Sundry Print Report

Well Name: MULE 11-14 FED COM

Type of Action: APD Change

Procedure Description: Devon Energy Production Co., L.P. (Devon) respectfully requests to change the well name, BHL, depth, and a slim hole design on the subject well. Devon is also requesting a variance for offline cementing and break test. Please see attached revised C102, Drill plan, directional plan, variance requests. API: 30-015-55053 Permitted Well name: MULE 11-14 FED COM 521H Proposed Well name: MULE 11-23 FED COM 302H Permitted BHL: SWSW, 20 FSL, 400 FWL, 14-25S-31E Proposed BHL: NWNW, 1294 FNL, 1540 FWL, 14-25S-31E Permitted TVD/MD: 8895/19134 Proposed TVD/MD: 10475/22182

WELL LOCATION AND ACREAGE DEDICATION PLAT

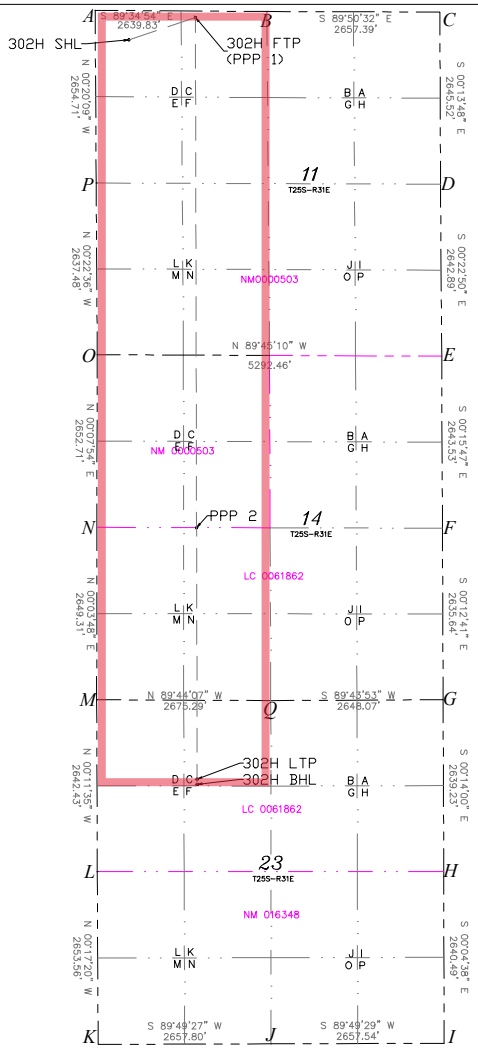
Devon Energy Production Co., L.P. (Devon) respectfully requests to change the well name, BHL, depth, and a slim hole design on the subject well. Devon is also requesting a variance for offline cementing and break test. Please see attached revised C102, Drill plan, directional plan, variance requests.

Permitted Well name: MULE 11-14 FED COM 521H
Proposed Well name: MULE 11-23 FED COM 302H
Permitted BHL: SWSW, 20 FSL, 400 FWL, 14-25S-31E
Proposed BHL: NWNW, 1294 FNL, 1540 FWL, 14-25S-31E
Permitted TVD/MD: 8895/19134
Proposed TVD/MD: 10475/22182

UL or lot No.	Section	Township	Range	Lot Idn	Feet from the	North/South line	Feet from the	East/West line	County
D	23	25-S	31-E		1294	NORTH	1540	WEST	EDDY
